Part 21 (PAR)

POTENTIALLY UNQUALIFIED COMPONENT IN CERTAIN ALLEN BRADLEY TIMING RELAYS

Part 21 Report No: P21-04302015

Subject: Report of potential 10CFR Part 21, Allen Bradley Timing Relay Model 700RTC

Figure 1- Original qualified design (prior to 2009).
Relays supplied prior to 2009 are not affected by this issue.

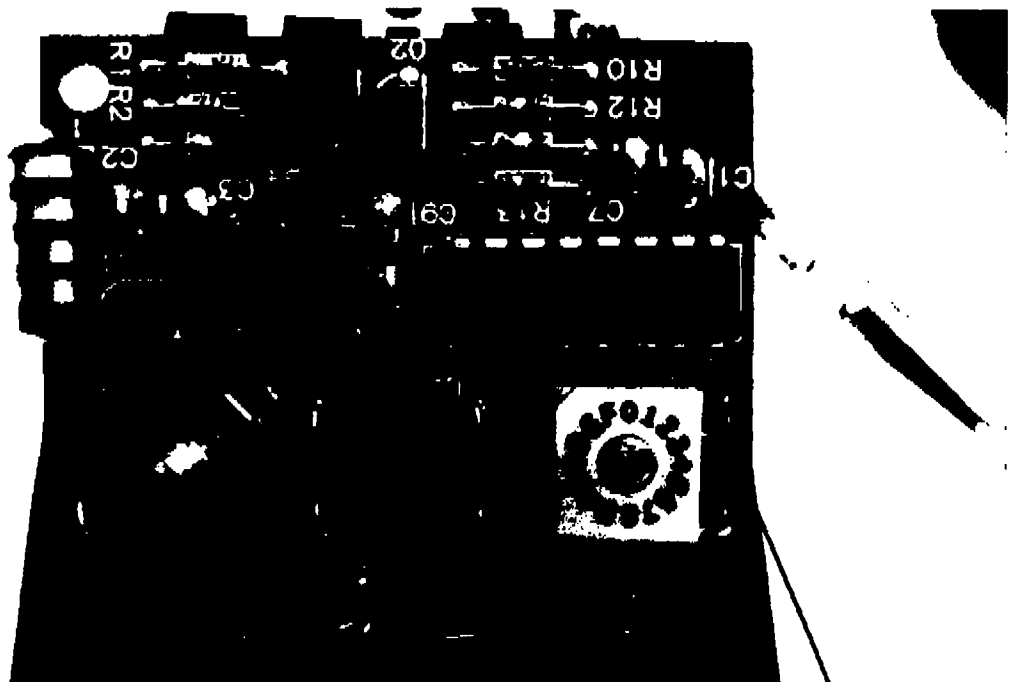
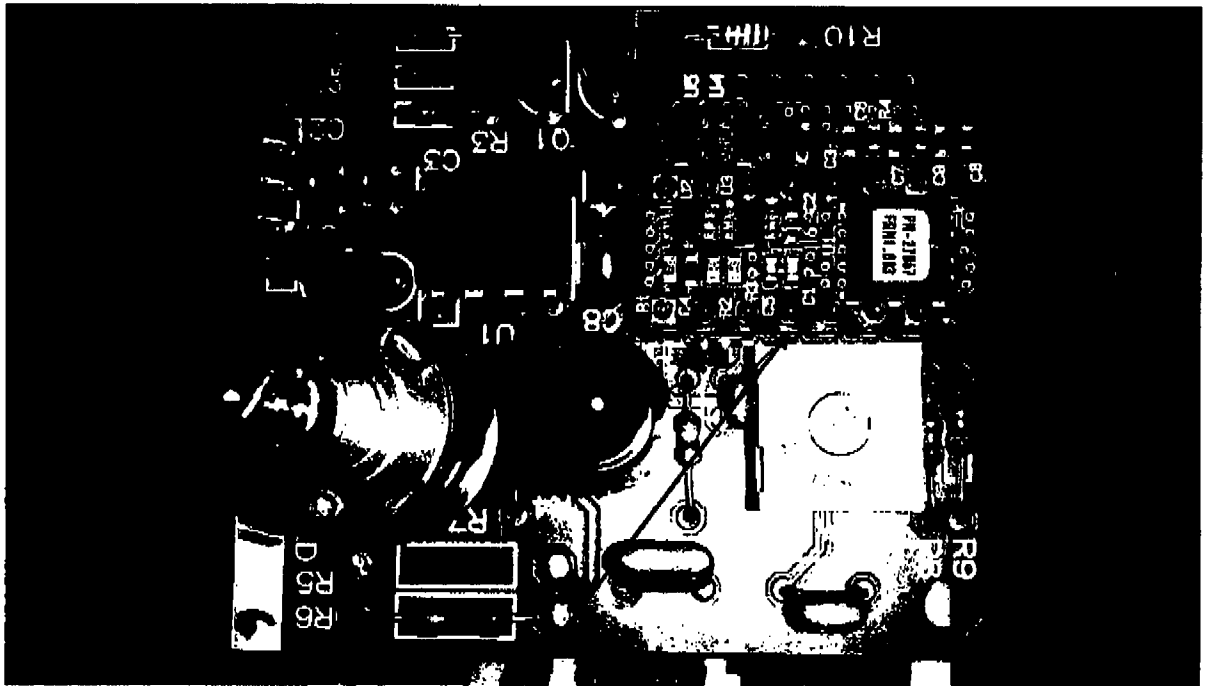
Between 2009-2010 Allen Bradley made a design change without changing the part number of the commercial relay or providing any documented evidence of a design change. The manufacturer specification data sheets maintain the classification that the relays are "solid state", which would imply that there are no digital devices installed in the relay. However, after inspection of the internals of the timing relay (Figure 2), it has been identified that the unit does contain a CPLD which meets the definition of a digital device under the guidance of NEI 01-01. See Figures 1 and 2 below:

The relays that are currently in stock at NLI have been placed on hold until after the units have been qualified for the specific application. NLI will perform EMC qualification testing per the requirements of EPRI TR-102323 Rev. 3 for the following tests, as applicable: CE101, CE102, RE101, RE102, RS101, RS103, CS101, CS114, CS115 and CS116. Estimated completion date is August 28, 2015.

The relays are dedicated for generic application usage in timing applications. The specific plant application(s) is unknown by AZZ. The EMC qualification of the relay is dependent on the installed configuration and location in the plant. The plant should evaluate whether the installed relays are subjected to unevaluated EMI/RFI conditions in the plant.
